**ITEM V-A: CONDITIONAL USE PERMIT AND DESIGN REVIEW PERMIT MODIFICATION –
MERRYHILL SCHOOL OF ORLANDO AV. – 1115 ORLANDO AV. – FILE# 2013PL-007
(CUP- 000081 & DRP-000479)**

REQUEST

Figure 3: Site Plan

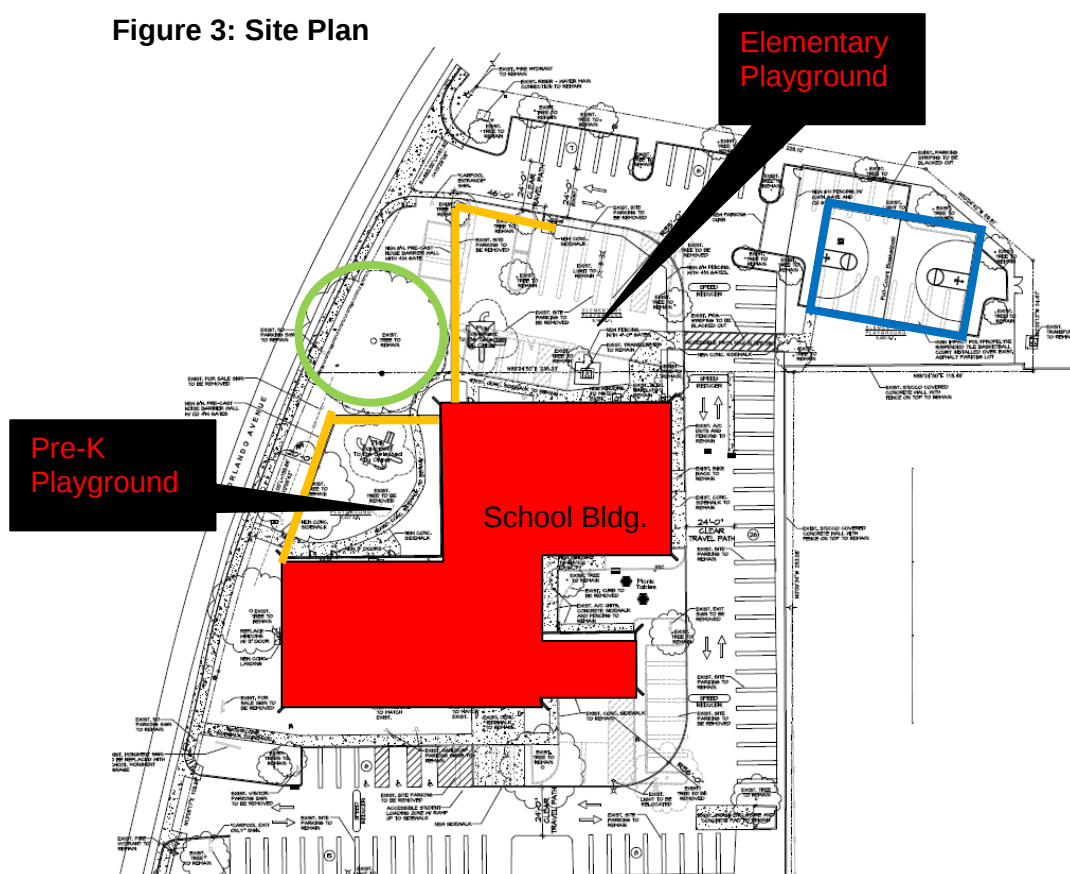
The existing 19,160 square foot office building is located in the center of the site (Figure 3; shown in red). The applicant has proposed to eliminate approximately 50 parking spaces in order to add outdoor play areas and additional loading areas for students at the front of the building. The outdoor play areas will be enclosed by two sound walls (shown in orange), and chain link fencing in some areas, to provide security and limit the roadway noise from Interstate 80 and Orlando Av. Also in this area is an existing native oak tree which is shown in green. The basketball court for the school is shown in blue.

The parking requirement for an office use (1:250) or 77 spaces in this instance, is significantly higher than a private elementary school (2 spaces per classroom; 32 spaces). Therefore the applicant does not need the amount of parking that the former office use required. As was discussed above, the loading areas are also sufficient and meet the Zoning Ordinance requirement. The proposed circulation pattern will create an orderly circulation pattern and will eliminate a dead end drive aisle where the basketball court will be located. As proposed the parking and circulation for the project will meet the intent of the Community Design Guidelines.
